Addendum / Addenda

Project Description / Description de projet		
M58 Abatement Ground Floor South		
Solicitation No./N° de sollicitation	Project No./N° de projet	W.O. No./N° d'ordre de travail
15-22093	5083	A1-006947-04-01
Departmental Representative / représentant ministériel		Date
Mark O'Connor		October 7, 2015
Notice:		Nota:
This addendum shall form part of the tender documents and all conditions shall apply and be read in conjunction with the original plans and specifications.		Cet addenda fait partie intégrale des dossiers d'appel; toutes les conditions énoncées doivent être lues et appliquées en conjonction avec les plans et les devis originaux.

project **M-58 HAZARDOUS MATERIAL ABATEMENT** projet
GROUND FLOOR, SOUTH WING

drawing **SCALE PLAN FOR ADDENDUM #1** dessin
 WHEN PRINTED TO SIZE INDICATED AT
 BOTTOM LEFT OF DRAWING

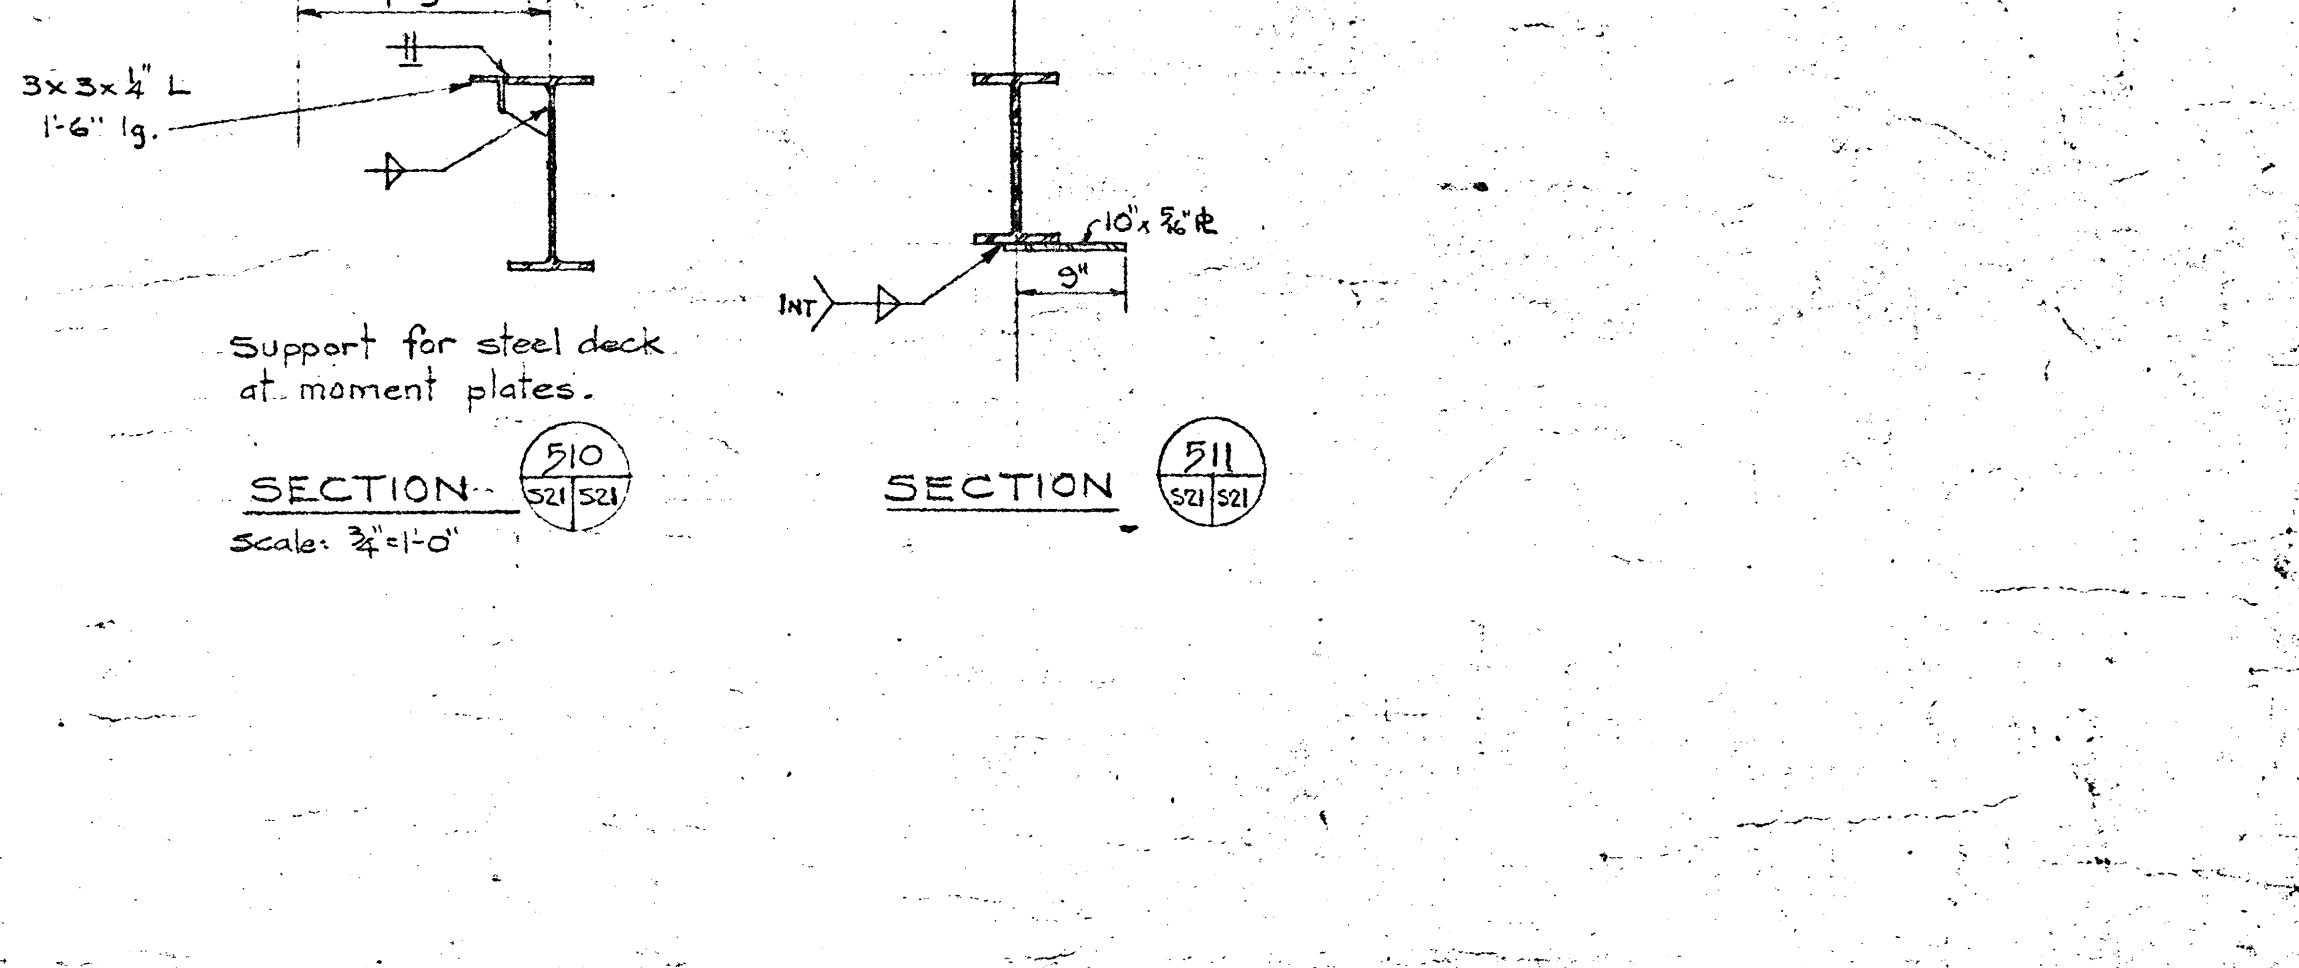
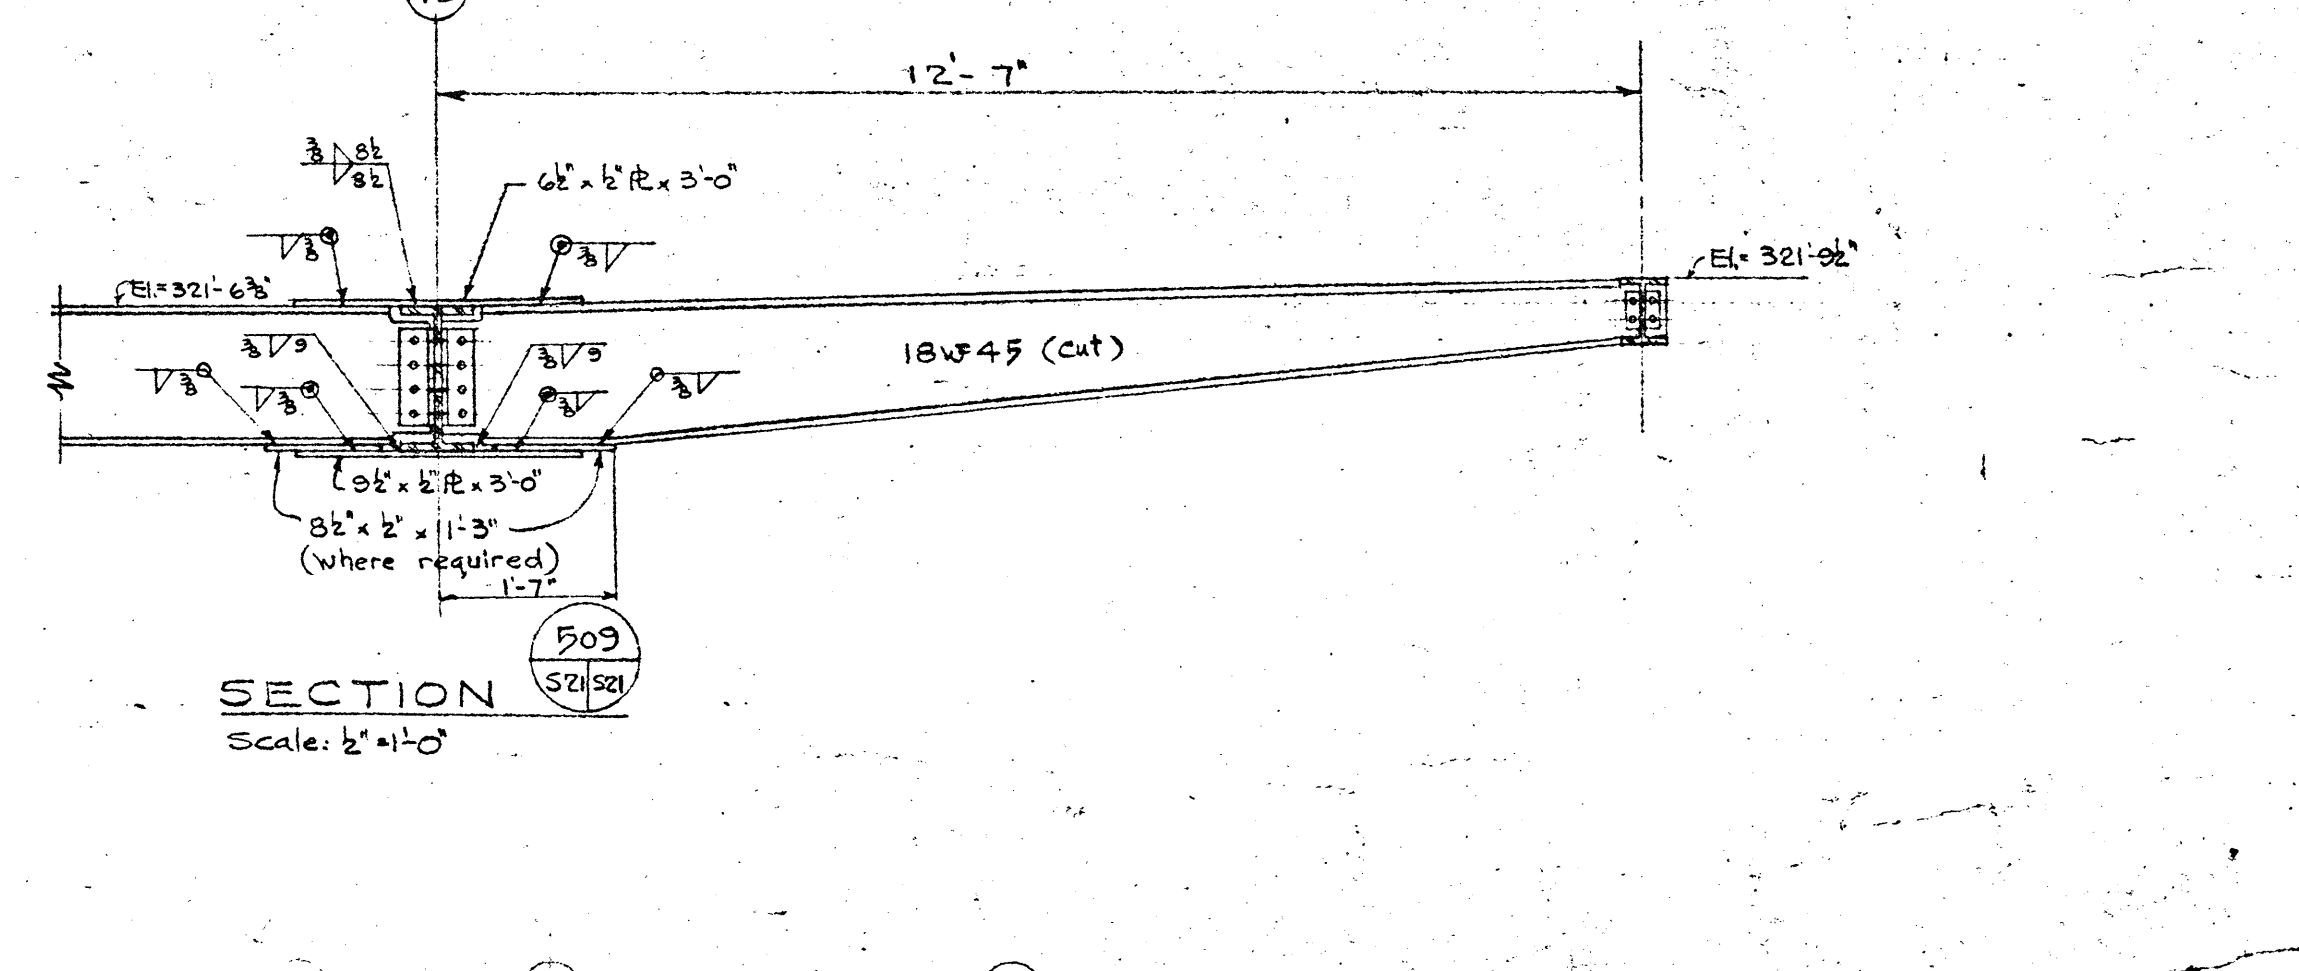
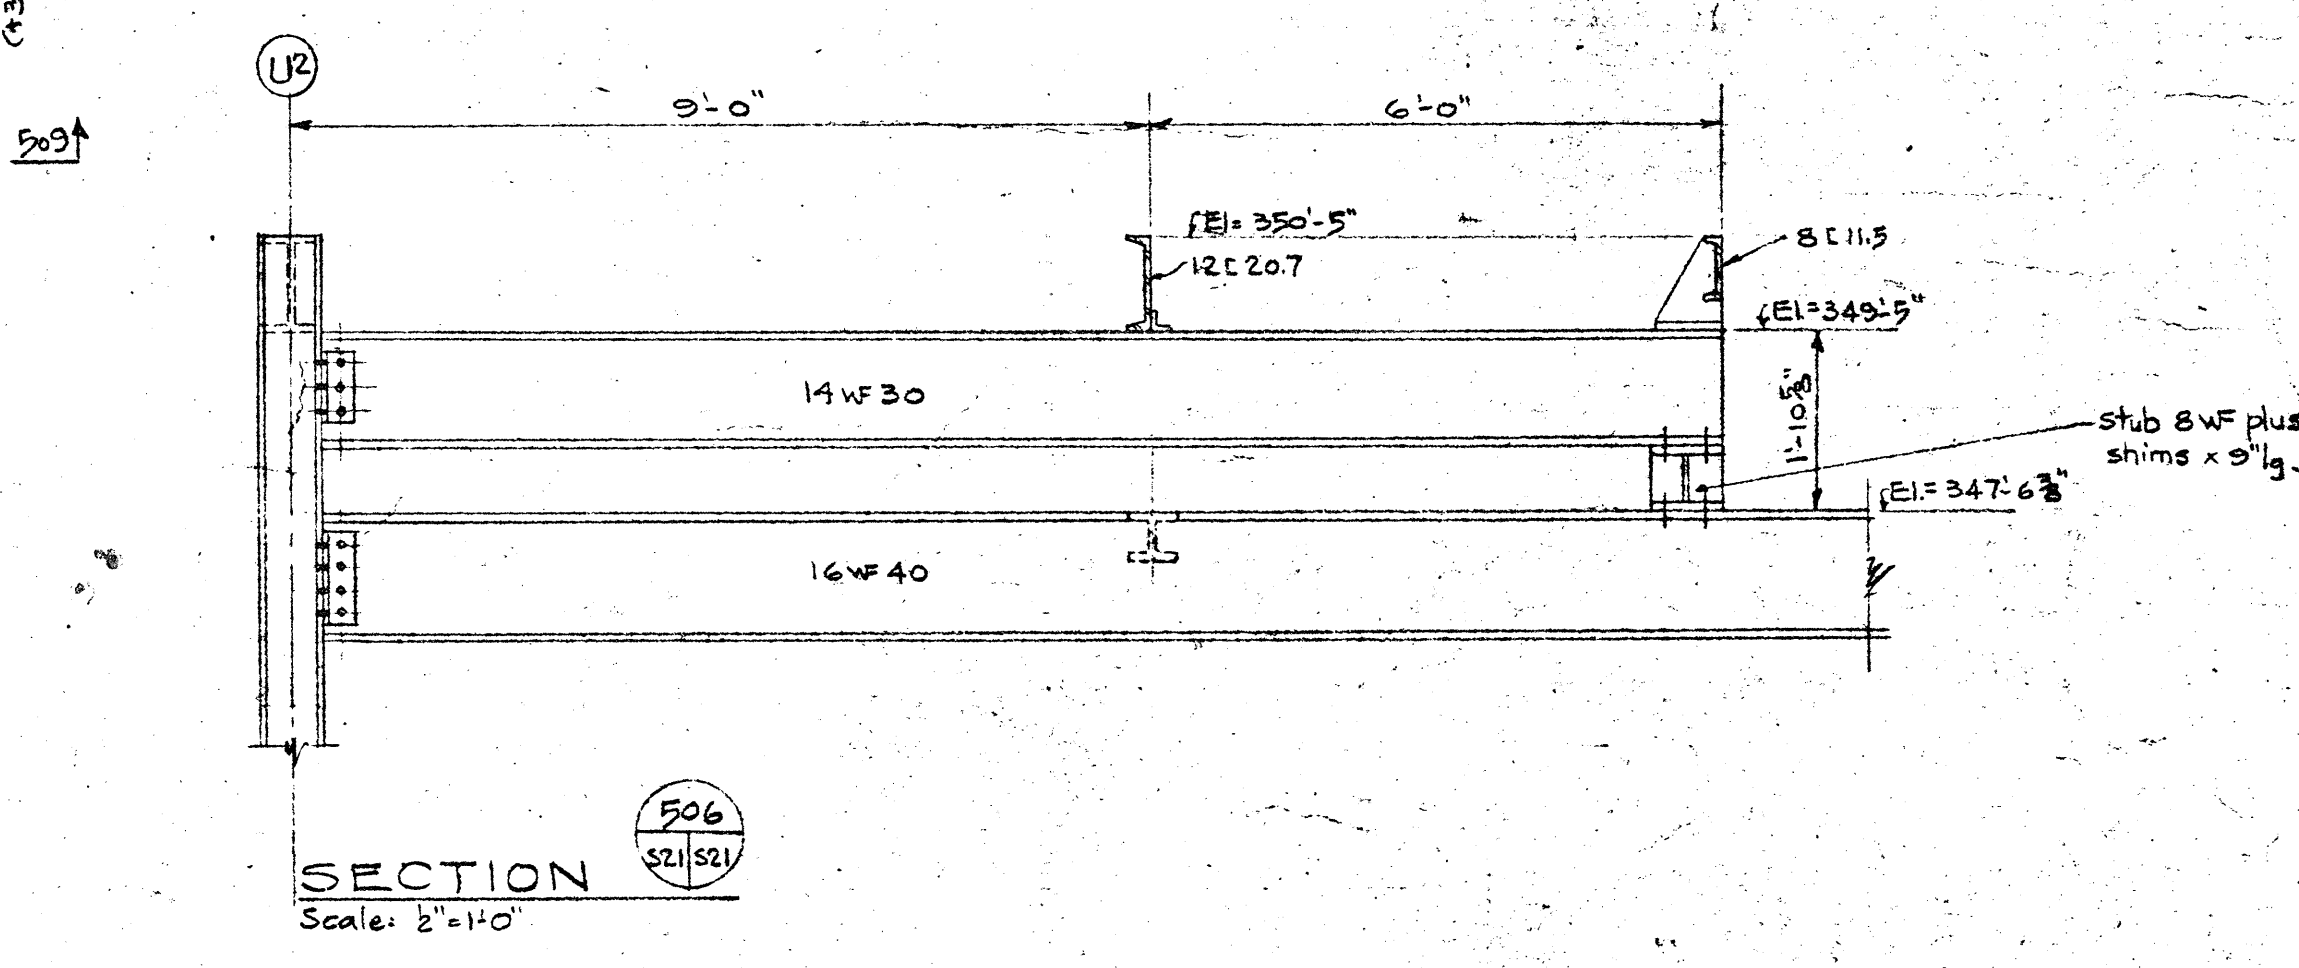
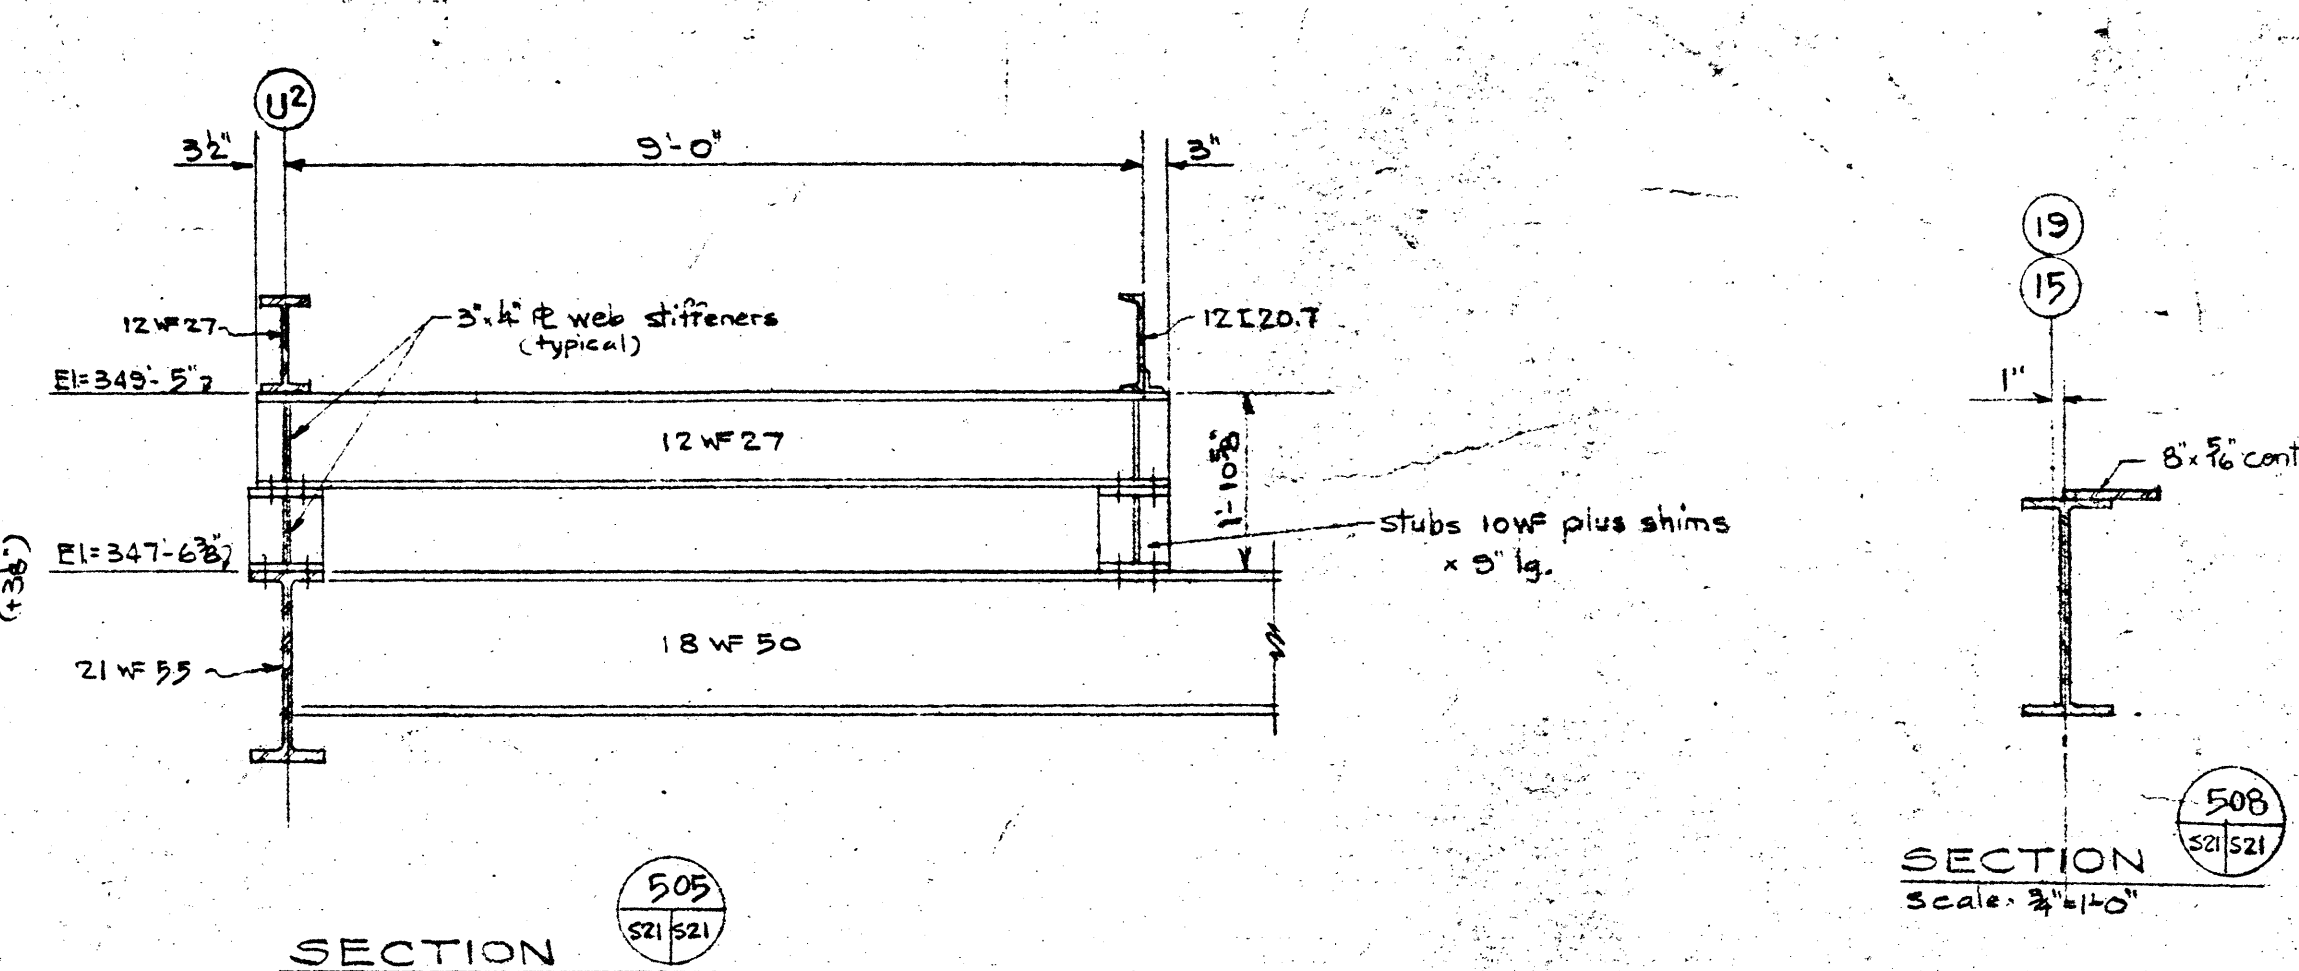
- 1 Steel drawings attached for reference. Drawing #S21
- 2 Scale architectural drawing attached for reference. Dated Oct 6 2015. Pipe chase noted on drawing that contractor must open to allow for abatement.
